MFN 09-224, Supplement 1

Docket No. 52-010

Subject: **Revised Response to Portion of NRC Request for Additional Information Letter No. 100 Related to the ESBWR Design Certification – RAI Number 21.6-103**

DCD Markups – Appendix 6E.5

Figure 6.2-14m3. Main Steam Line Break, 1 SRV Failure (Bounding Case, with Offsite Power) – Drywell and GDCS Noncondensable Gas Pressures (2000 s)

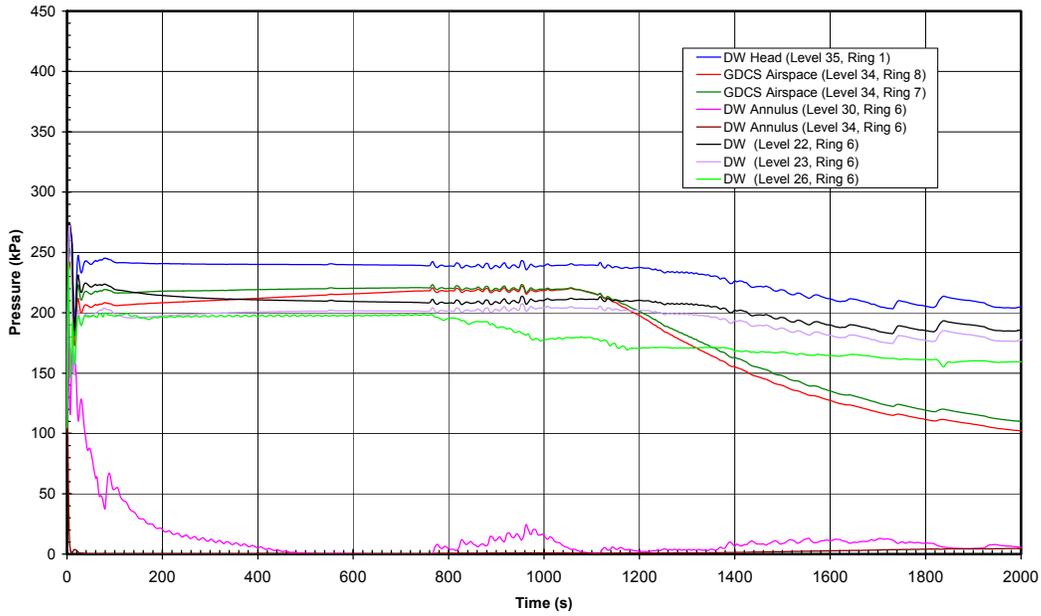
Tier 2 Chapter 06	26A6642AT	Figure 6.2-14m4	Main Steam Line Break, 1 SRV Failure (Bounding Case, with Offsite Power) – Drywell Annulus and Suppression Pool Levels (72 hours)
Tier 2 Chapter 06	26A6642AT	Figure 6.2-14m5	Main Steam Line Break, (Bounding Case, with Offsite Power) – GDCS Pool Levels (72 hours)
Tier 2 Chapter 06	26A6642AT	Figure 6.2-14m6	Main Steam Line Break, (Bounding Case, with Offsite Power) – GDCS Pool Temperature (72 hours)
Tier 2 Chapter 06	26A6642AT	6.3.2.7.1	GDCS Design Basis
Tier 2 Chapter 06	26A6642AT	6.3.2.7.2	GDCS System Description
Tier 2 Chapter 06	26A6642AT	6.3.2.7.4	GDCS Testing and Inspection Requirements
Tier 2 Chapter 06	26A6642AT	6.3.2.7.5	Instrumentation Requirements
Tier 2 Chapter 06	26A6642AT	6.3.2.8.2	ADS System Description
Tier 2 Chapter 06	26A6642AT	Table 6.3-1	Significant Input Variables to the ECCS-LOCA Performance Analysis

Figure 6.2-14m4. Main Steam Line Break, 1 SRV Failure (Bounding Case, with Offsite Power) Drywell Annulus and Suppression Pool Levels (72 hrs)

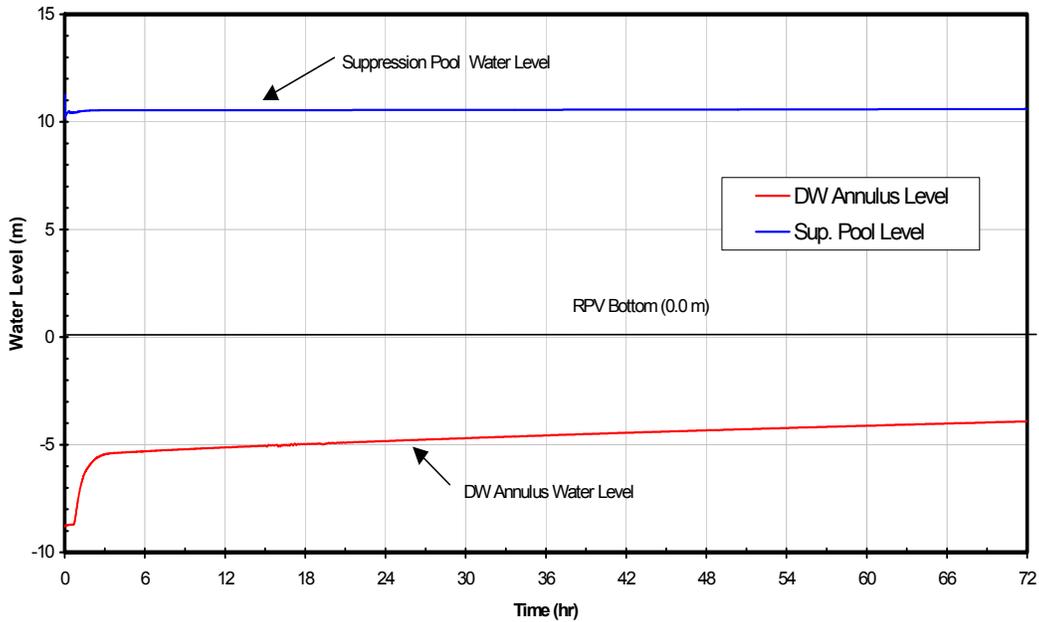
Figure 6.2-14m4 compares the water levels in the DW annulus and suppression pool. The DW annulus water level rises due to the break flow discharges from the main steam line broken piping. The DW annulus water level remains in the lower DW and does not enter into the bottom of the suppression pool via the spillover holes.

Figure 6.2-14m5. Main Steam Line Break, 1 SRV Failure (Bounding Case, with Offsite Power) GDCS Pool Levels (72 hrs)

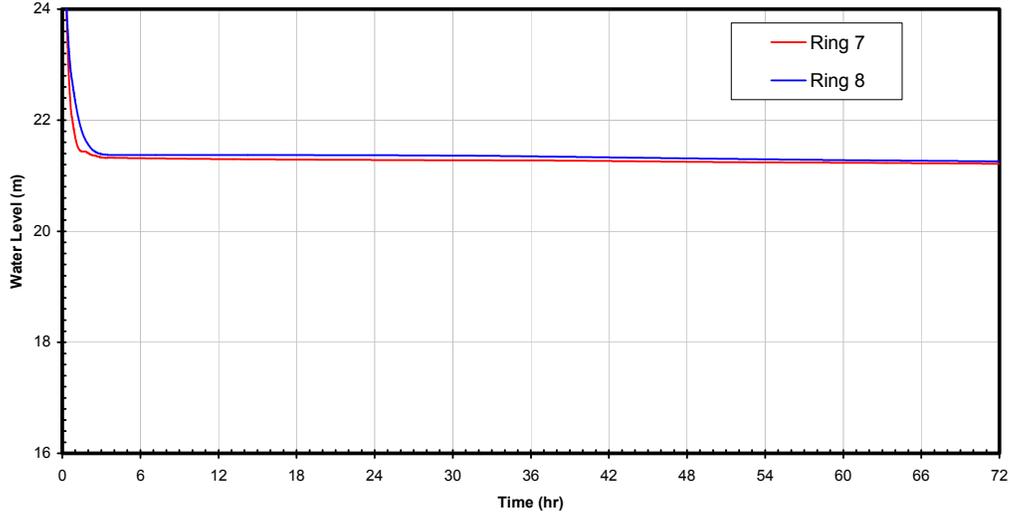
For MSLB, the GDCS pool level (Figure 6.2-14m5) drops to the elevation of the DPVs and stays above L33 (Figure 6.2-7). As no gas mass is stored below L33, gas masses stored in the top two levels (L34 and L35) are purged to minimal values in a few hours through the connection pipes. Approximately 60% (or 1200 m³ (42380 ft³)) of the initial GDCS cold water 46.1°C (115°F) remains inside the GDCS pools. The hot PCCS condensate mixes with the cold GDCS pool water. The temperature of the GDCS water injected into the RPV is lower than that of the FWLB. A portion of the decay heat is used to heat up the incoming colder GDCS water, which is shown in Figure 6.2-14l3 as the difference between the decay heat and the total PCCS condensation power. It takes approximately 60 hours to bring the mixture temperature to approximately 95°C (Figure 6.2-14m6).
